# single-engine SERVICE LETTER

SE77-35

**SUBJECT:** MUFFLER SUPPORT MODIFICATION

**AIRCRAFT APPLICABILITY:** 1971 thru 1977 Model 177RG/Cardinal RG Series Aircraft

Figure 1. L. H. Forward Muffler Support Modification (177RG)

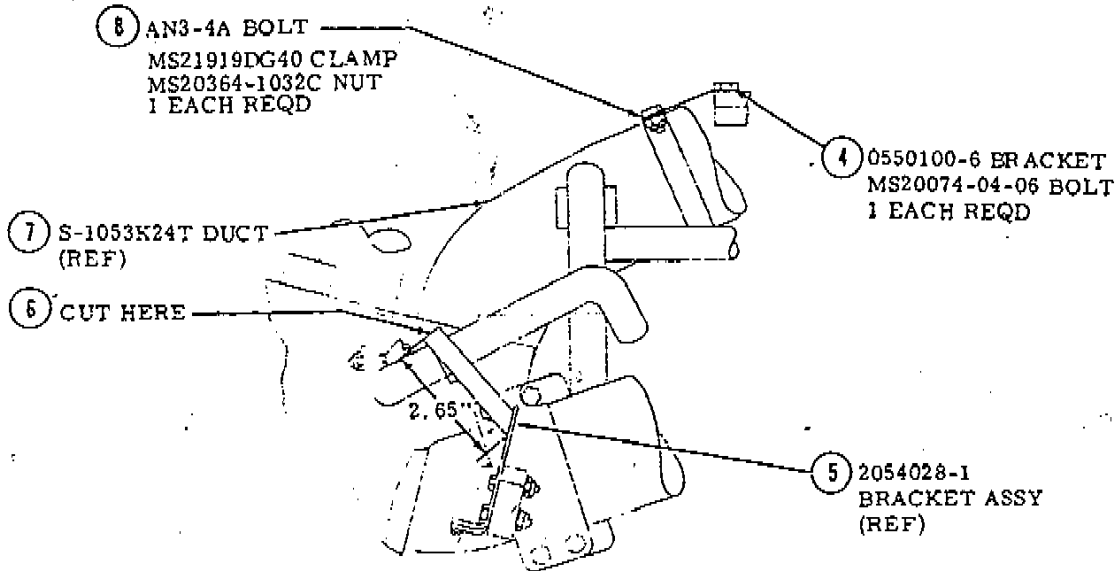
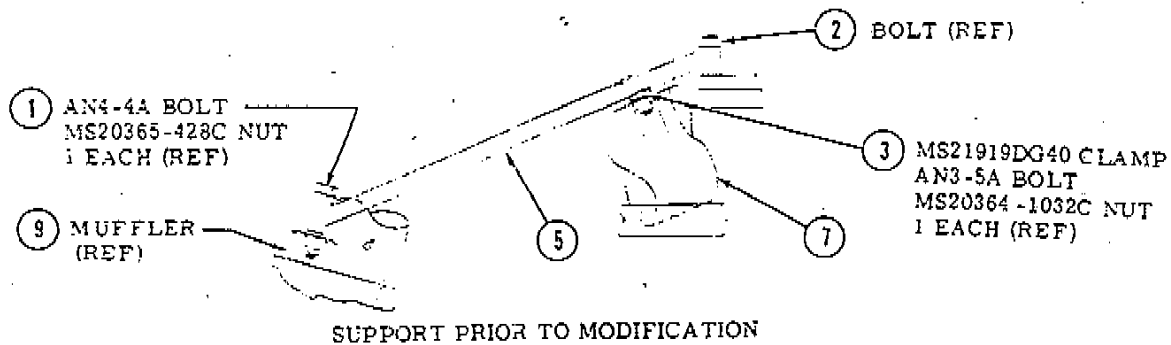
The left hand forward muffler support has been deleted from mufflers installed on production Cardinal RG aircraft to reduce vibration stresses and provide improved muffler service life.

It is recommended that this support also be removed from earlier in service aircraft within the next 100 hours of operation. (Reference attached Figure 1)

1. Remove bolt and nut (1) securing support bracket (5) to muffler (9).
2. Remove bolt (2) securing support (5) to the engine.
3. Remove bolt and nut (3) securing clamp (3) to duct (7).
4. Cut the bracket assy (5) at the 2.65" dimension (6).
5. Install bracket (4) on engine with bolt (4).
6. Locate clamp (8) on duct (7) and secure to bracket (4) with bolt and nut (8).
7. Modified bracket becomes a new part number 2054028-3.

1 MOD KIT INSTL - MUFFLER BRACKETS

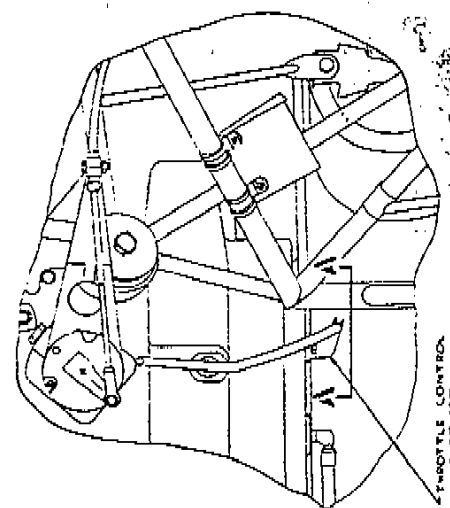
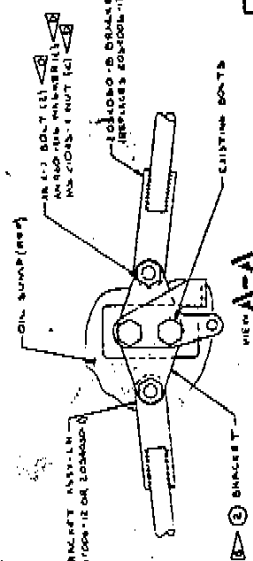
The brace system which attaches the aft end of both exhaust mufflers to the engine sump has been improved.

It is recommended that the new brace system be installed on in service aircraft to improve the security and service life of the center and rear muffler braces and throttle control brackets.

INSTALLATION INSTRUCTIONS:  
 A. REMOVE (DISCARD) EXISTING MUFFLER BRACKETS  
 B. REMOVE (DISCARD) EXISTING MUFFLER BRACKET  
 C. INSTALL THE -2 BRACKET TO THE THROTTLE  
 CONTROL BRACKET TO THE OIL PUMP USING  
 THE EXISTING HARDWARE  
 D. INSTALL THE HARDWARE  
 E. ATTACH THE NEW BRACKETS TO THE -2 BRACKET  
 USING ANTI-ROST (L), ANTI-48 WASHER (L) &  
 ANTI-ROST-NUT (L)
